7.7 Control Systems Not Required for Safety

The information in this section of the reference ABWR DCD, including all subsections and figures, [as modified by the STP Nuclear Operating Company Application to Amend the Design Certification rule for the U.S. Advanced Boiling Water Reactor \(ABWR\), "ABWR STP Aircraft Impact Assessment \(AIA\) Amendment Revision 3," dated September 23, 2010](#) is incorporated by reference with the following departures and supplements.

Figure 7.7-11 Simplified Functional Diagram of the Automatic Power Regulation System

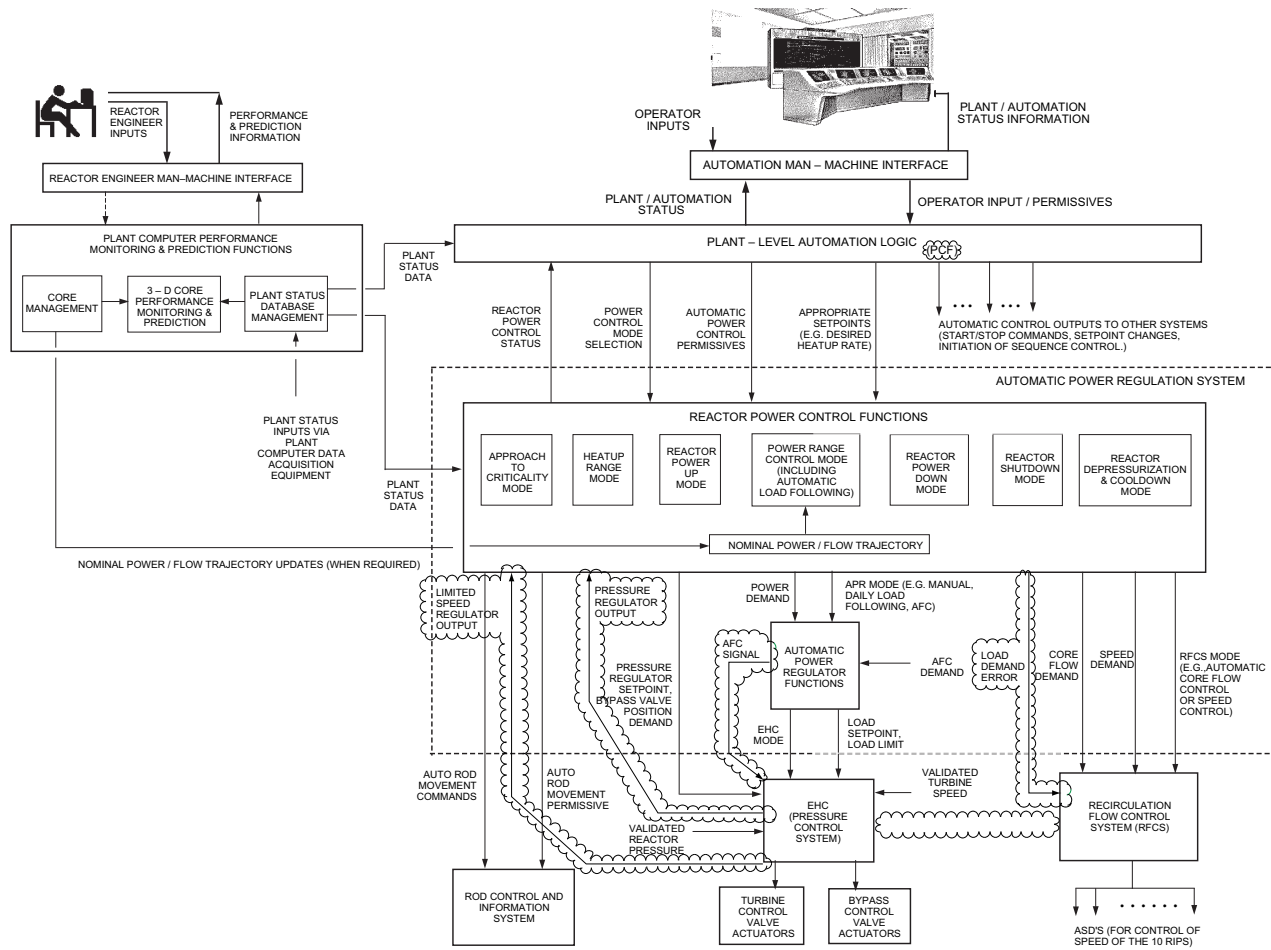
STD DEP 7.7-20 (Figures 7.7-5, 7.7-7, 7.7-11)

STD DEP 7.7-24 (Figures 7.7-11, 7.7-12, 7.7-13)

The primary objective of the Automatic Power Regulator (APR) System is to control reactor power during reactor startup, power generation, and reactor shutdown, by appropriate commands to change rod positions, or to change reactor recirculation flow. The secondary objective of the APR System is to control the pressure regulator setpoint (or turbine bypass valve position) during reactor heatup and depressurization (e.g., to control the reactor cooldown rate). The APR System consists of redundant process controllers. Automatic power regulation is achieved by appropriate control algorithms for different phases of the reactor operation which include approach to criticality, heatup, reactor power increase, automatic load following, reactor power decrease, and reactor depressurization and cooldown. The APR System receives input from the ~~plant computer~~ PCE, the Power Generation Control System (Subsection 7.7.1.5.42), the Steam Bypass and Pressure Control System (Subsection 7.7.1.8), and the operator's control console. The output demand signals from the APR System are to the RCIS to position the control rods, to the RFC System to change reactor coolant recirculation flow, and to the SB&PC System for automatic load following operations. The ~~PGS~~ PGCS performs the overall plant startup, power operation, and shutdown functions. The APR System performs only those functions associated with reactor power changes and with pressure regulator setpoint (or turbine bypass valve position) changes during reactor heatup or depressurization. A simplified functional block diagram of the APR System is provided in Figure 7.7-11.

For reactor power control, the APR System contains algorithms that can change reactor power by control rod motions, or by reactor coolant recirculation flow changes, but not both at the same time. A prescribed control rod sequence is followed when manipulating control rods for reactor criticality, heatup, power changes, and automatic load following. Each of these functions has its own algorithm to achieve its designed objective. The control rod sequence can be updated from the ~~process computer~~PCF based on inputs from the reactor engineer. A predefined trajectory of power-flow is followed when controlling reactor power. The potentially unstable region of the power-flow map is avoided during plant startup, automatic load following, and shutdown. During automatic load following operation, the APR System interfaces with the SB&PC System to coordinate main turbine and reactor power changes for optimal performance.
